Fairbanks Trails Inc

Subject: VA002-24 Trail Realignment

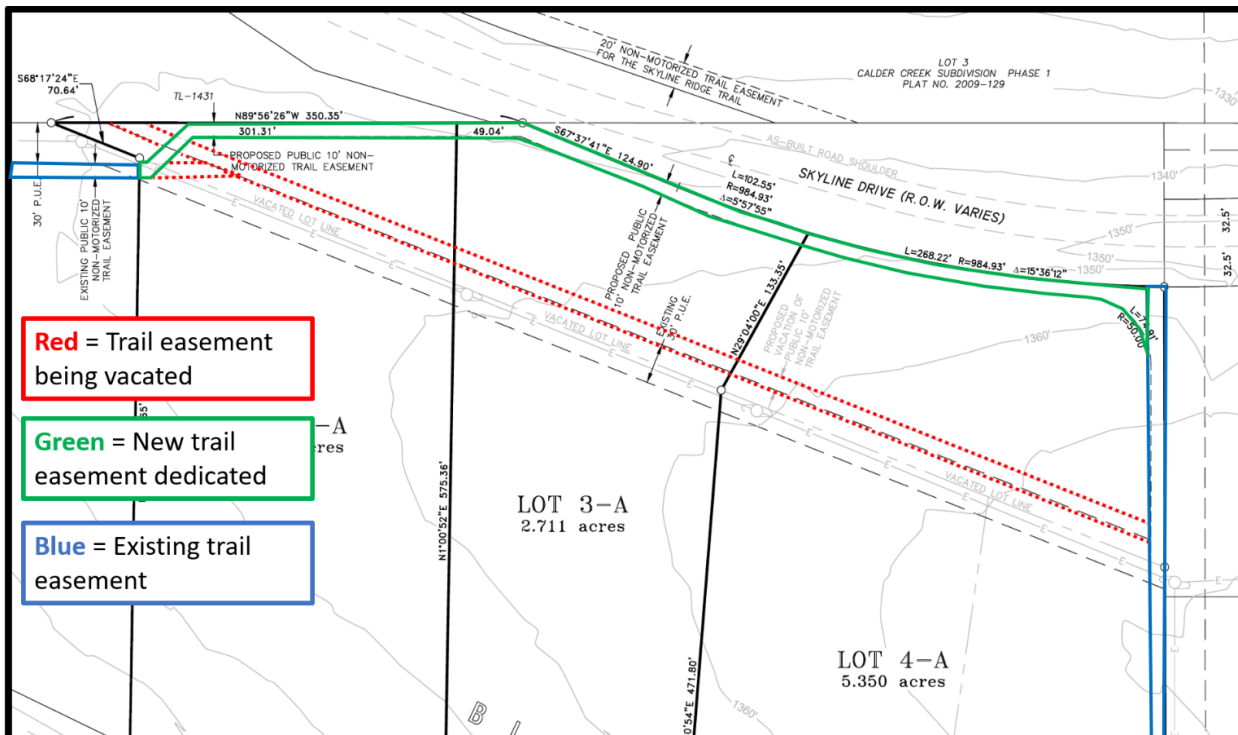
- The reroute is more on the north facing slope so less sun and worse soils.
- The reroute has a side slope where the existing easement is level side to side.
- The reroute is on the road embankment for about 40 feet with a steep side slope.
- The reroute is within sight, sound, and smell of the road where the existing easement provides some buffer to the road.

The second test in 17.32.030(E)(1) is that the existing route be "no longer practical for the uses or purposes authorized." The existing trail is on the north side of a 30-foot-wide cleared utility easement containing a GVEA power line. The new houses will likely be south of the powerline thus the trail should not interfere with the planned development. The existing route is practical for a narrow pedestrian trail.

- Connection with Skyline Ridge trail is provided by the easement along the east side of the property. The proposed realignment does not improve the connection to Skyline Ridge Trail.

- The subdivision trails were originally provided to be quiet paths through the woods. They were not intended to serve as a path along Skyline Drive. It is unlikely that pedestrians on Skyline Drive will use the proposed easement. No transitions from the road to the trail are provided. For pedestrians on the road to access the rerouted trail they would have to go through the ditch and up a steep embankment. In the winter there would be snow berms to scramble over.

- The existing trail alignment is more beneficial than the proposed realignment that puts the trail adjacent to a busy road and adds turns.
